**IFB No. 17-26 Eisenhower Middle School HVAC and Roof Access Renovations**

**RE: ADDENDUM NO. 1**

Changes to Bidding Documents Dated January 13, 2017

PROJECT: EISENHOWER MIDDLE SCHOOL  
HVAC AND ROOF ACCESS RENOVATIONS  
ROCKFORD PUBLIC SCHOOLS 205  
ROCKFORD, ILLINOIS

1 ALT. M1: POOL TUNNEL HVAC PLAN  
SCALE: 1/8" = 1'-0"

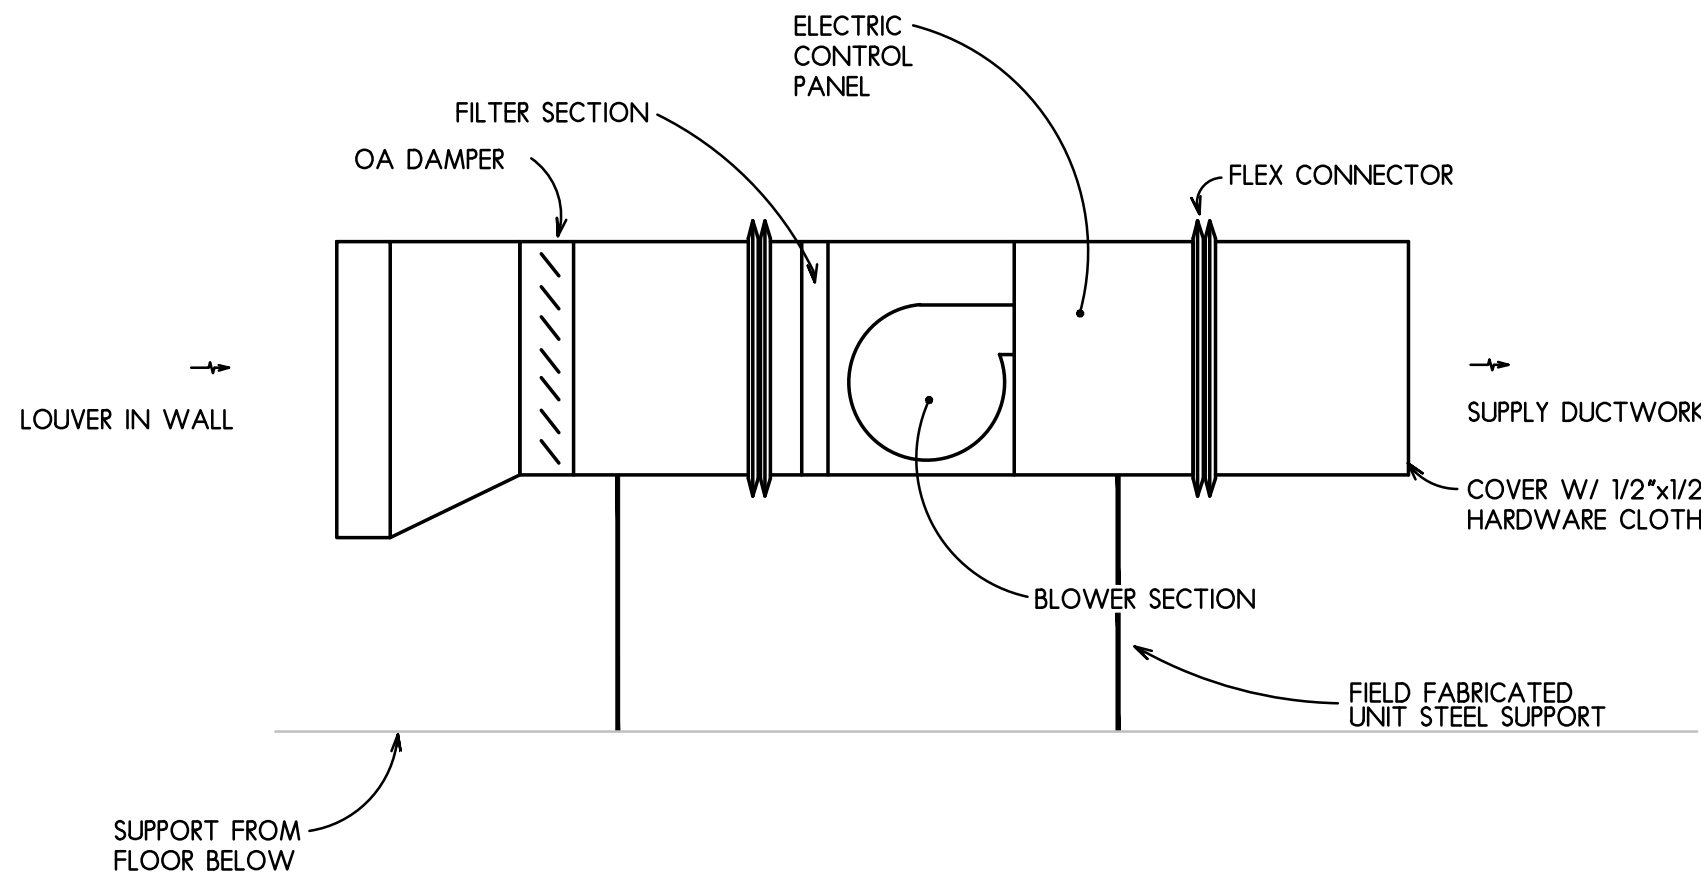
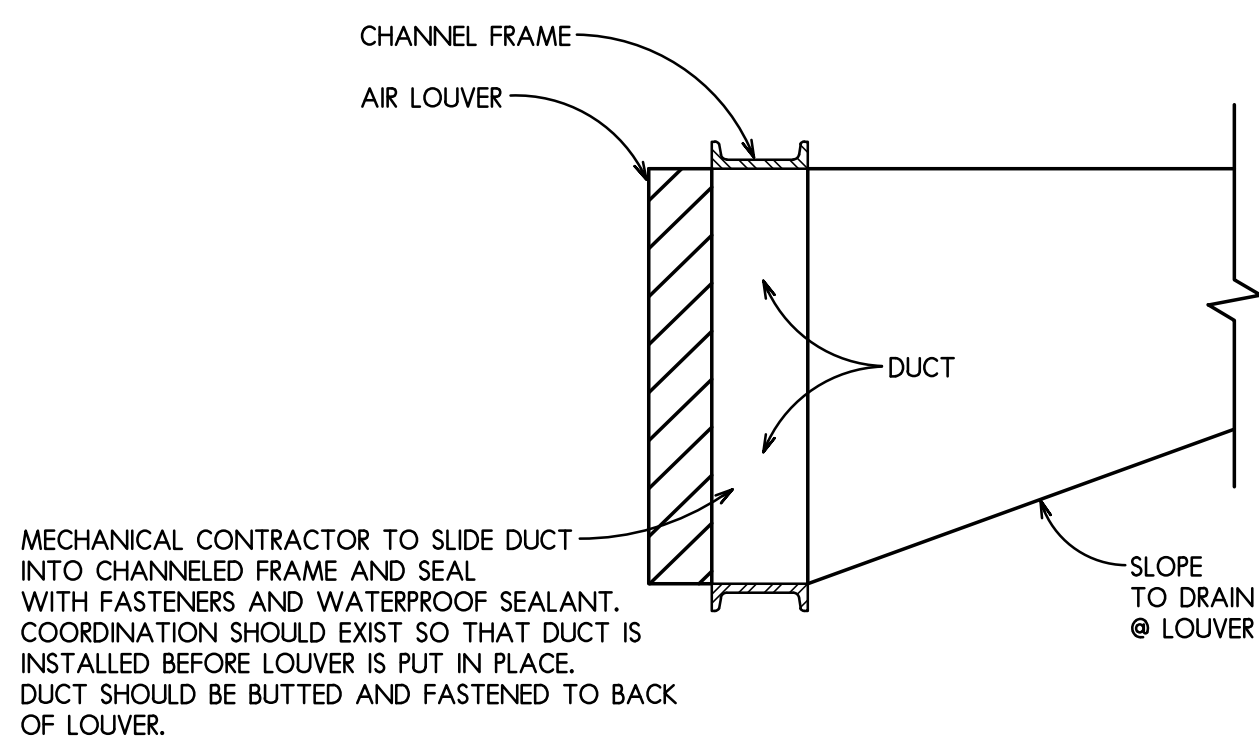
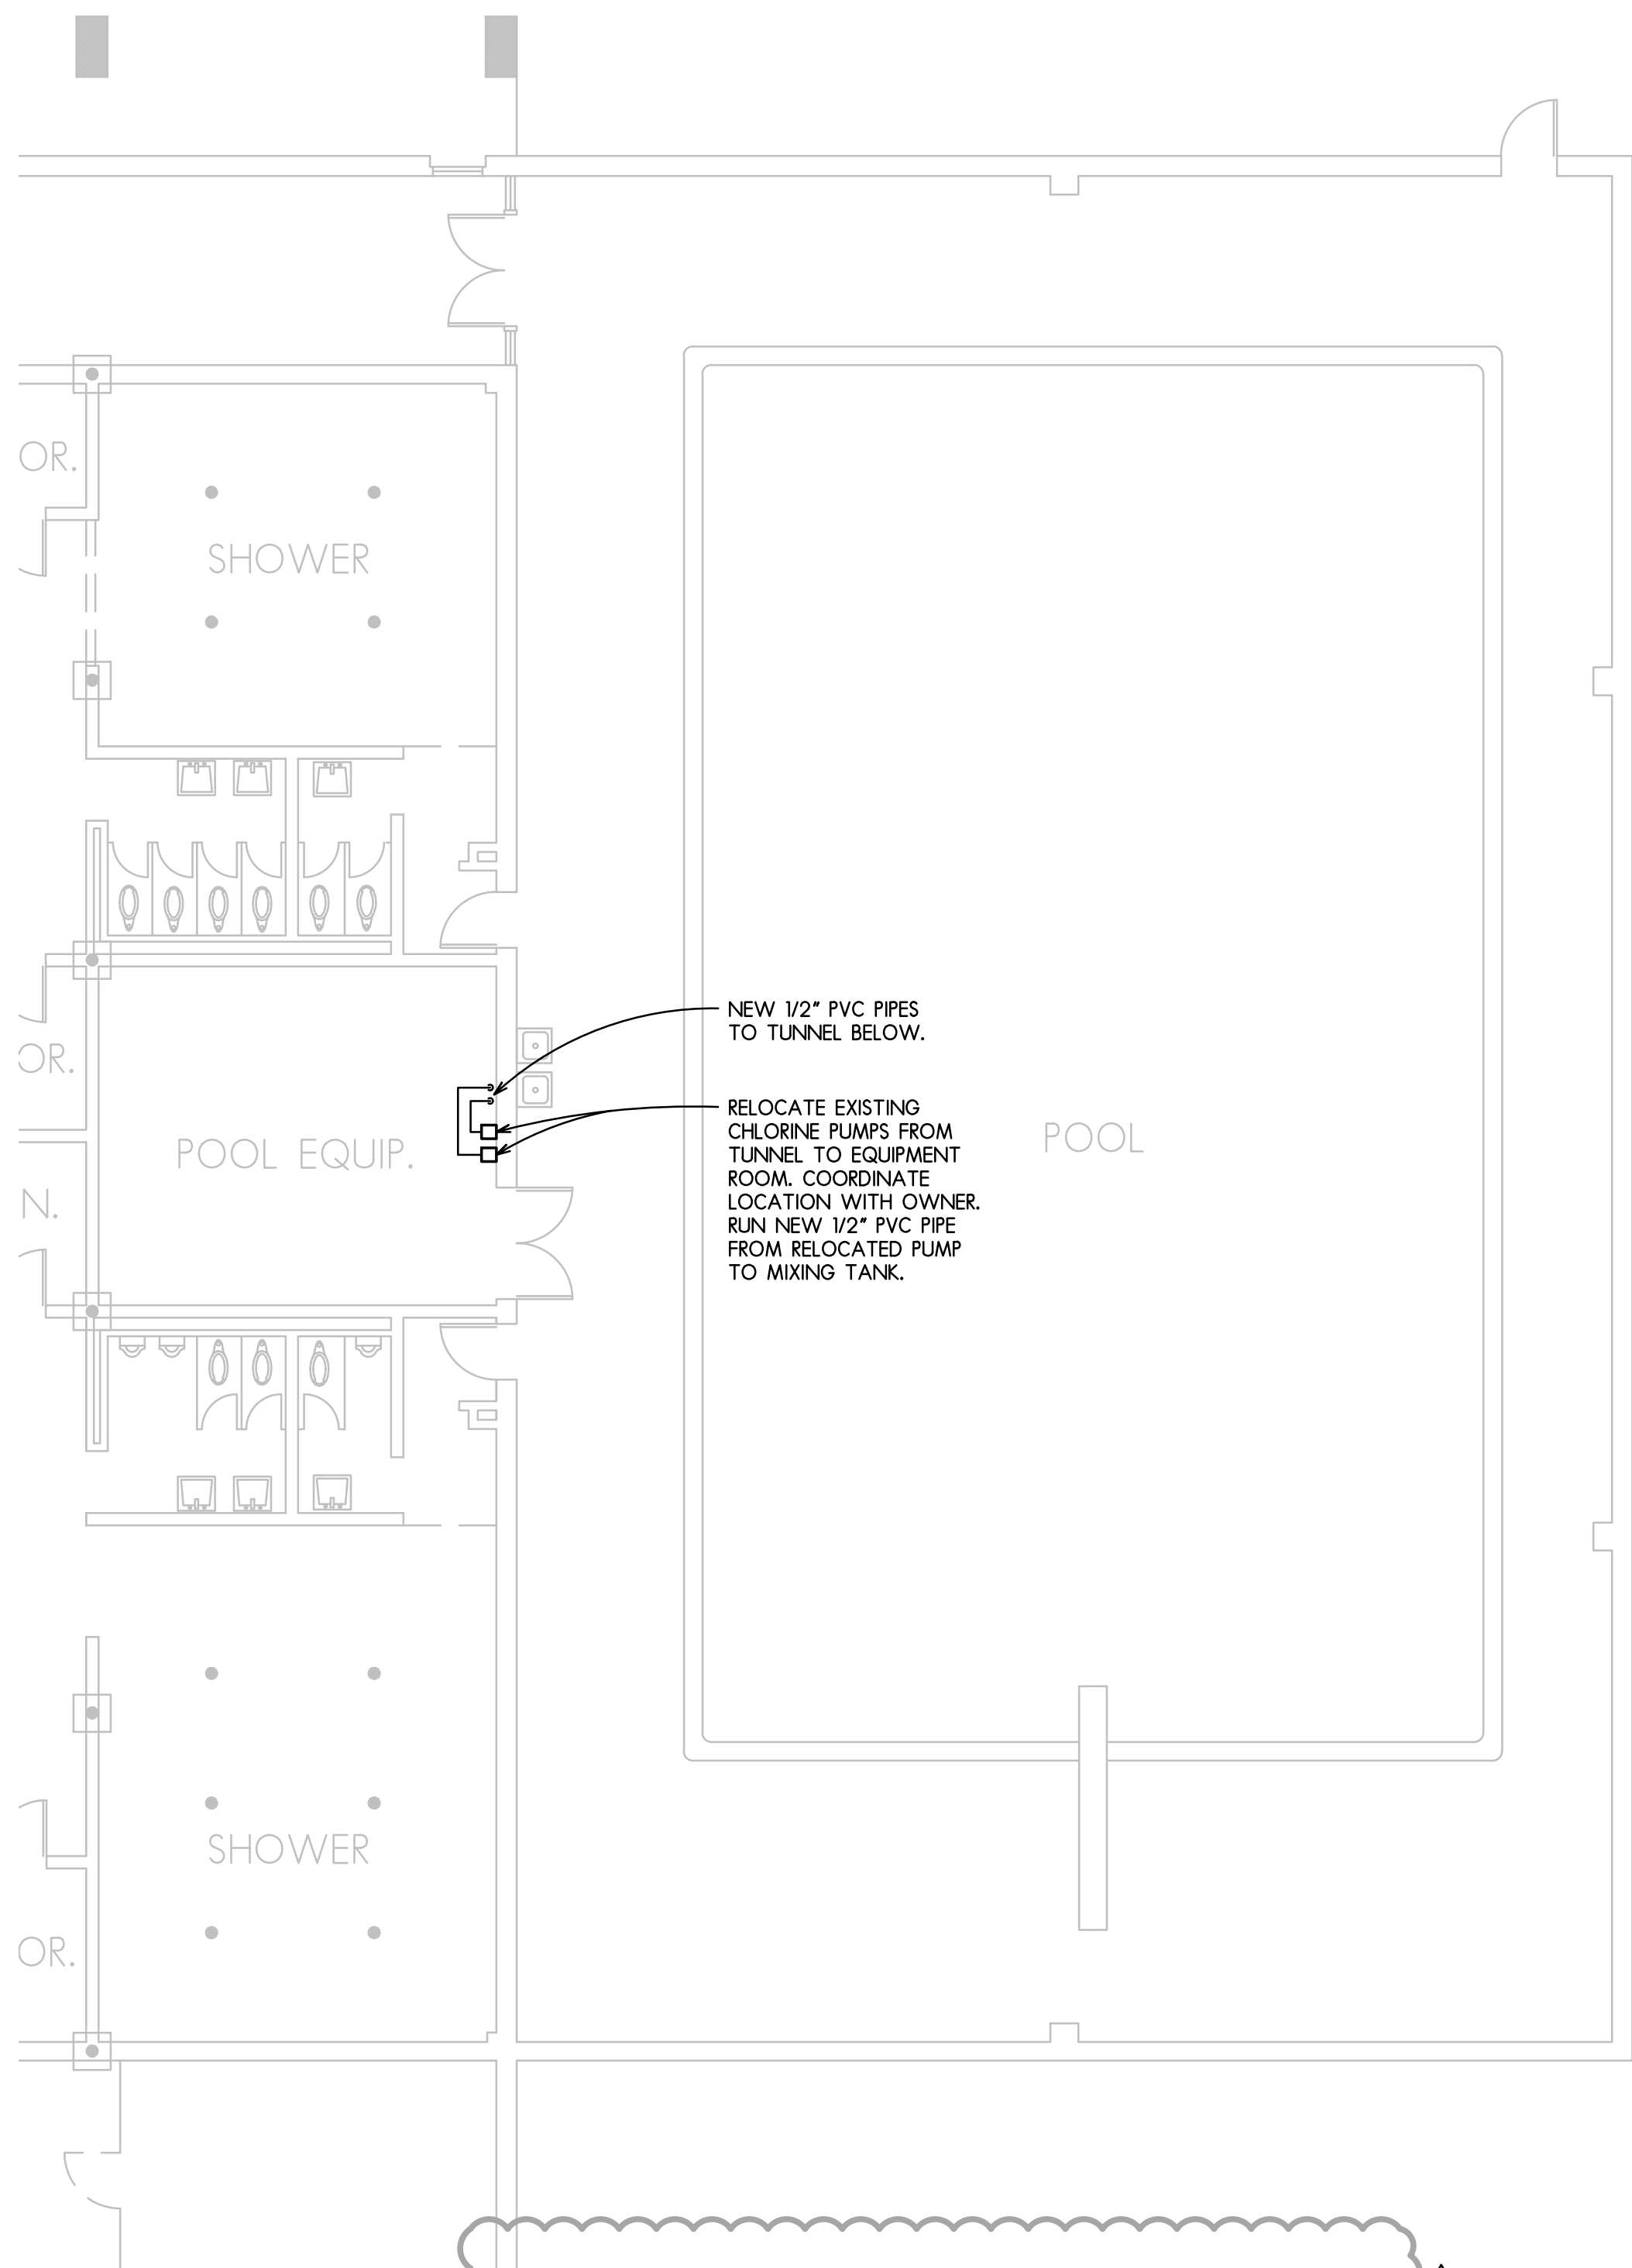
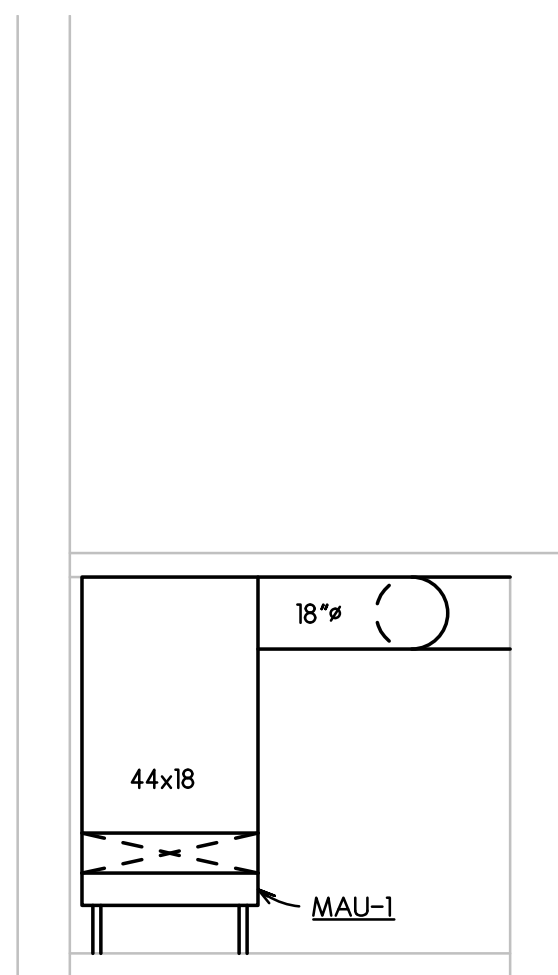
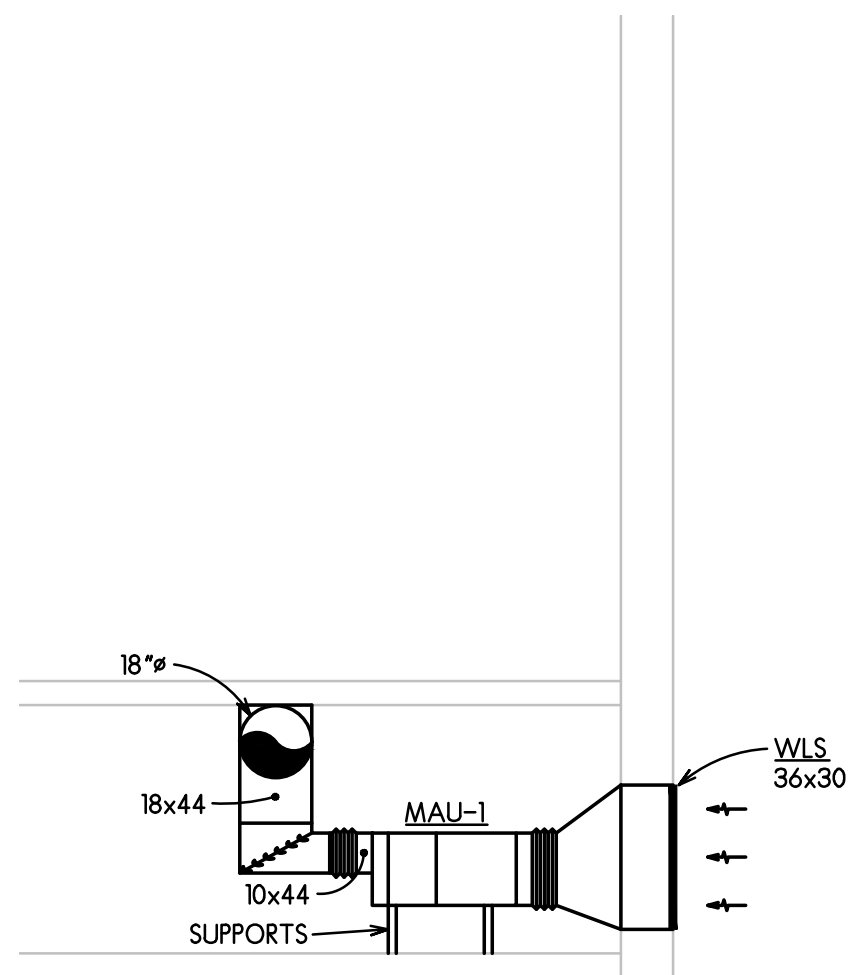
3. Which H.V.A.C. units are part of the pool ventilation, electrical, controls, roof patching, etc.?  
**Refer to attached sheet re-issued sheets M1.3 & E1.0.**
